Urgent Field Safety Notice *SBN-CPS-2020-014*

9180 Electrolyte Analyzer - wrong arrow direction for Calcium results on system display

Product Name	9180 Electrolyte Analyzer
System	9180 Electrolyte Analyzer
GMMI / Part No Device Identifier	9180 Electrolyte Analyzer / 03157334001
Production Identifier (Product name/Product code)	03157334001
SW Version	All versions
Type of Action	Field Safety Corrective Action

Figure 1

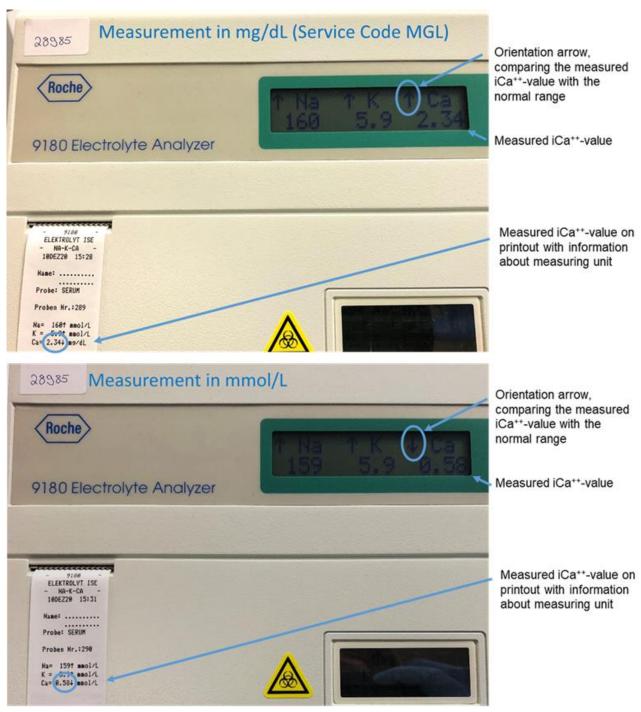
During internal verification studies the following possible scenario was observed: if the unit for iCa++ is set to mg/dL (Service Code MGL configured) and a measured iCa++-value is lower than the normal range, an upward arrow is shown on the display instead of a downward arrow independent of serial number or software version.

The displayed numeric result is correct and on the printout result and arrow direction are shown correctly.

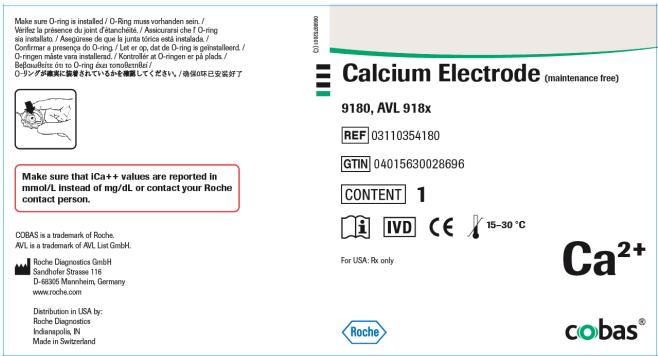
In addition, a violator will be added into the leaflet of iCa++ electrode as follows:

This disclaimer will be included into the leaflet of all future iCa++ electrode lots. Update leaflets are expected to be available from Q2 2021.
